Groundwater Application Review Summary Form

Application # G- 19207 re-review #2

PUBLIC INTEREST REVIEW FOR GROUNDWATER APPLICATIONS

TO: Water Rights Section Date 2/12/2025
 FROM: Groundwater Section Travis Brown
 Reviewer's Name
 SUBJECT: Application G- 19207 re-review #2 Supersedes review of 11/9/2022
 Date of Review(s)

Well Location Map

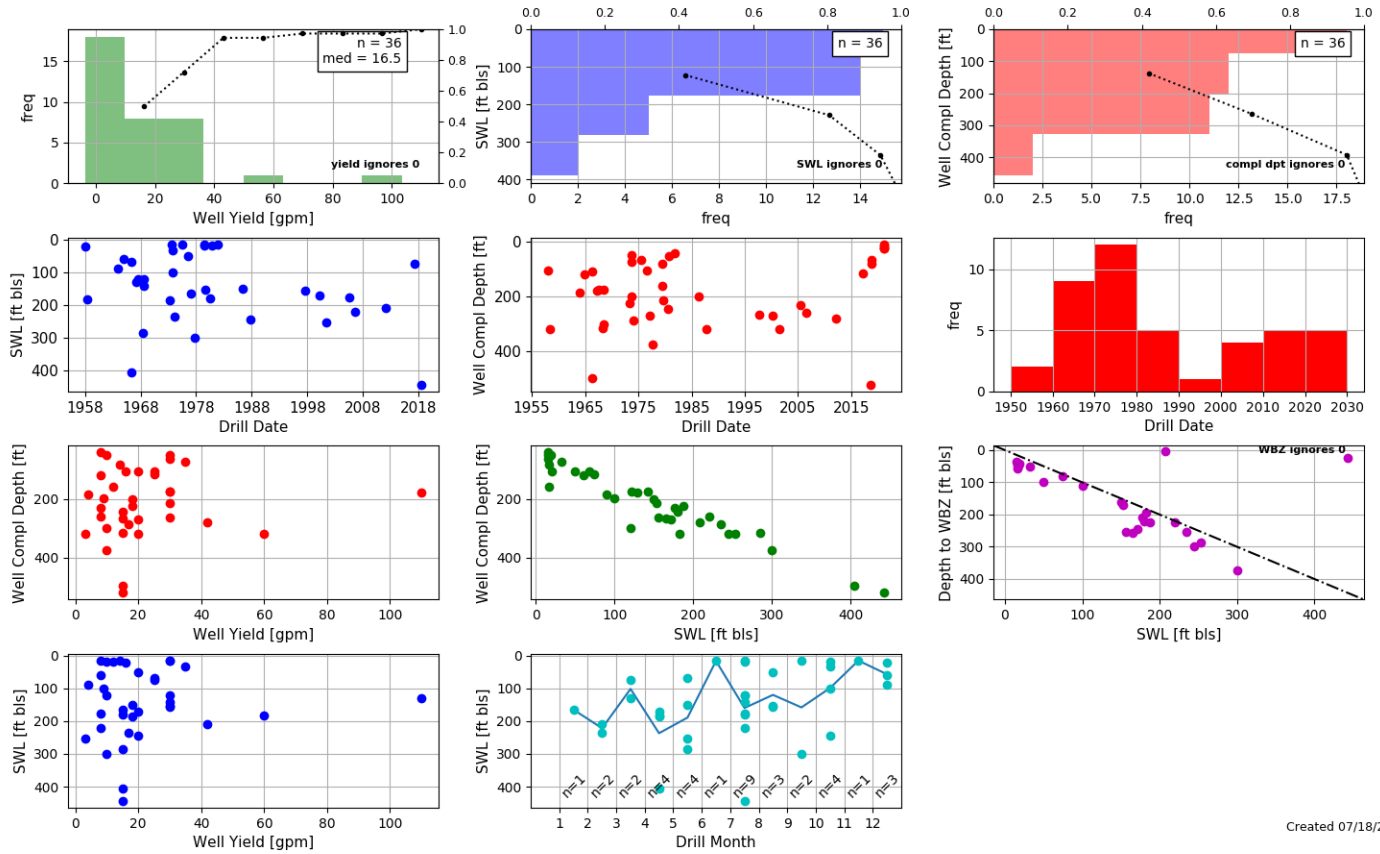
The nearest well (CLAC 397) to the proposed POA is located about 2100 ft southeast (See attached Well Location Map). Interference with CLAC 397 was quantitatively estimated using a Theis (1935) distance-drawdown model for a boundary condition. Hydraulic parameters used for the analysis were derived from regional data and studies (Pumping Test Reports; Conlon et al., 2005; McFarland and Morgan, 1996). The analysis shows that the pumping at the proposed well may cause minimal (<1 ft) drawdown at the nearest well after 365 days of pumping at the maximum requested rate (see attached Well Interference Analysis). However, several exempt domestic wells are presumed to be closer than CLAC 397 to the proposed POA. Regardless, given the low requested rate (0.0088 cfs), the proposed use of groundwater is not anticipated to cause interference with neighboring wells sufficient to meet the definition of injury.

Water-Level Measurements in Nearby Wells

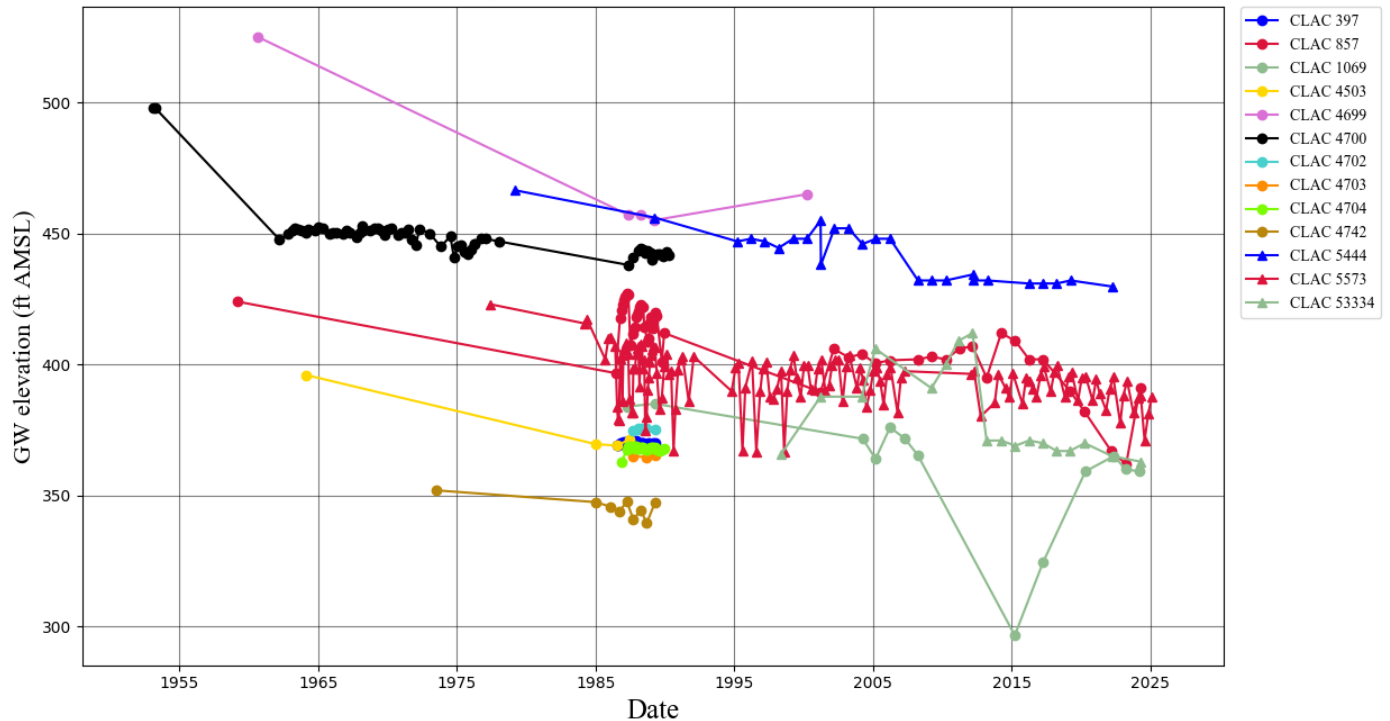
Recent groundwater level time series data are limited in the adjacent area of the proposed POA. The state observation well closest to the proposed POA is CLAC 5573 (completed in Deep Troutdale). The attached hydrograph shows seasonal variations in groundwater levels, however relatively stable groundwater levels over the period of last 30 years. CLAC 5444 – completed in the Deep Troutdale (sandstone) – shows an overall decline of ~37 ft in groundwater level over the period of record, although water levels since 2008 have been fairly stable. Measurements within the last decade generally show a more mixed history, with some wells continuing to decline (CLAC 5573, CLAC 53334) while others appear more stable (CLAC 5444) or even show recent recovery (CLAC 857, CLAC 1069). Despite this mixed water level behavior and the lack of current water level data in the Deep Troutdale (sandstone) in the immediate vicinity of the proposed POA, the most recent water levels in the nearest Deep Troutdale wells are generally not declined excessively or excessively declining; therefore,
